# ORAU COMMENTS/RECOMMENDATIONS PRELIMINARY RESULTS AND RECOMMENDATIONS OF THE INDEPENDENT ASSESSMENT OF PARCEL EVALUATION FINDINGS REPORT FORMER HUNTERS POINT NAVAL SHIPYARD, SAN FRANCISCO, CALIFORNIA

# ATTACHMENT: PROPOSED SOIL APPROACH RECAP AND ORAU COMMENTS/RECOMMENDATIONS

cpm for Cs-137 by Subpopulation at 900 Volts

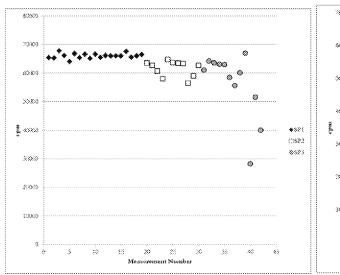
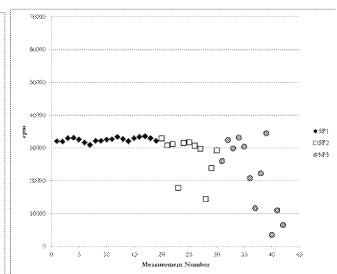
background responses are characteristic of a 2-inch by 2-inch NaI(Tl) scintillation detector. ORAU uses similar detectors and has extensive experience with the detector and expected responses. Multiple instances were seen in Appendix C where detector response was as low as 2,000 to 3,000 cpm, while the more common low end of quoted response ranges were 4,000 to 5,000 cpm (which although on the lower tail of the typical response distribution is not unusual). However, the 2,000 cpm values are highly unusual unless: (1) the detector is being operated in a shielded or windowed configuration; (2) the detector being used in those survey units had a crystal smaller than  $2\times2$ ; (3) the area surveyed was anomalous as exhibiting a very low background; or (4) the detector crystal had degraded and the operating voltage was not set properly. Based on the various count rates reported in Appendix C, the most probable reason is a degraded or otherwise unstable measurement system. As such, there is a possibility that the detector was significantly under-responding, especially to low energy photons. The following figures showing data from an ORAU study on detector performance illustrate this point. The figures represent gamma energy response from three NaI 2×2 populations to mid- and low-range energy photons (Cs-137 and Am-241, respectively). The populations were new detectors (SP1), 2 to 5-year old detectors (SP2), and detectors more than 5-years old (SP3). All were operated at the manufacturer's recommended high voltage. Response degradation is clearly evident.

If the measurement system was degraded or otherwise unstable, then the mean plus 3 sigma action levels provided in supplementary data packages are likely to be deficient for these detectors. Most

action levels were quoted in the 6,000 to 9,000 cpm range. Therefore, the potential for undetected contamination is highest in those survey units where these detectors were used. Additional evaluations would be necessary to confirm the type of detector and stability of the measurement system and affected survey units to make this determination.

For the survey performance observation in Section 2.1, ORAU recommends a thorough review of the complete instrumentation operational packages for both suspect and non-suspect detector systems. Records for review include electronic calibration, high voltage plateaus, daily operational background and check source responses, and field records representing various use periods for the selected detectors.

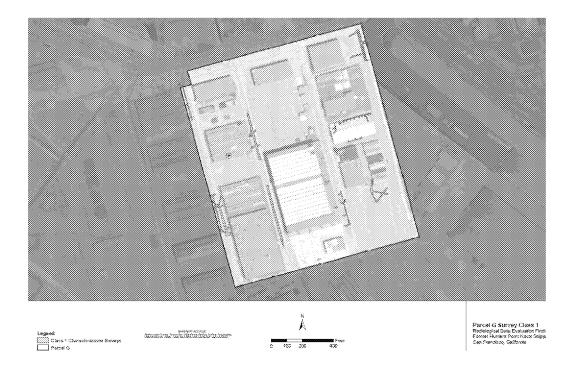
- A. Documentation provided to ORAU, including the various parcel radiological data evaluation findings reports and the *Basewide Radiological Removal Action Memorandum (BRRAM)*, does not imply or otherwise state whether the DCGL/risk/dose compliance criteria include application of the unity rule. Rather, the text provides general statements, such as the following in Sections V.A., V.A.1, and V.A.5 of the BRRAM:

- c) "Application of soils, debris, and surface cleanup goals to sites: MARSSIM guidance"
    - Per Appendix A of the BRRAM, "The Navy would apply this requirement..."—in reference to the Radiological Criteria for Unrestricted Use at Closing NRC Licensed Facilities—"...with the exception that 15 mrem/yr TEDE is substituted for 25 mrem, as ALARA." As the Table 1 residual doses range from 0.05263 to 25 mrem/yr for the respective release criteria, ORAU assumed a the time of this review that the unity rule could be required to demonstrate compliance. Since that time and participation in the January 17 and 18 technical team, it is ORAU's understanding that the criteria apply independently. Whether the release criteria apply independently, but more importantly if the unity rule is required, the Navy should consider increasing m (background reference area) and n (survey unit) sample populations from 18 to minimize Type II error probabilities. Otherwise, consider assessing available sample data to estimate the mean and standard deviation (in terms of unity if the unity rule will be applied, or if not, for each primary radionuclides of concern (ROCs) to estimate the worst case relative shift. Next, evaluate the relative shift and corresponding sample size with the proposed n and m of 18. Prepare a prospective power curve to assess probability of Type II error.

- ii. Additionally, the Class 3 plan specifies a 99% confidence that the concentrations of ROCs do not pose a risk. The plan should specify the confidence level (and

associated Type I error) for the Class 1 investigation. Will the planned confidence be the default of 95% (Type I decision error limit of 0.05) or is the intent to also impose 99% confidence (Type I decision error limit of 0.01) in the release decision for Class 1 areas? If the latter, the selected Type I error may also impact the necessary sample size. For example, the proposed sample populations of 18, assuming the default regulator acceptable error 0.05 (95% confidence level) and Type II error of 0.05 corresponds to a relative shift of 1.5. However, if the Type I error is changed to 0.01 (99% confidence) and all other variables are held constant, the population for n and m increases to 25 to achieve the desired confidence level.

B. Although the rectangular sample pattern is acceptable for this type of planned investigation, the recommendation is that a triangular pattern be substituted to increase probability of identifying residual areas of elevated radionuclide of concern (ROC) concentrations, in particular for survey units where scanning may provide limited information due to backfilling or otherwise assessing subsurface soils.

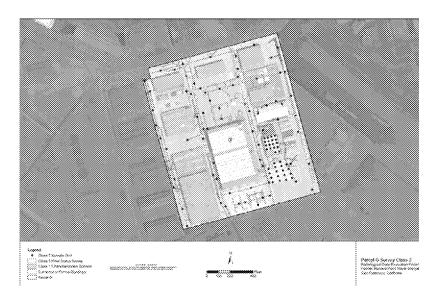
A. Refer to comment/recommendations A.i, A.ii, and B above for Proposed Approach Item 1.
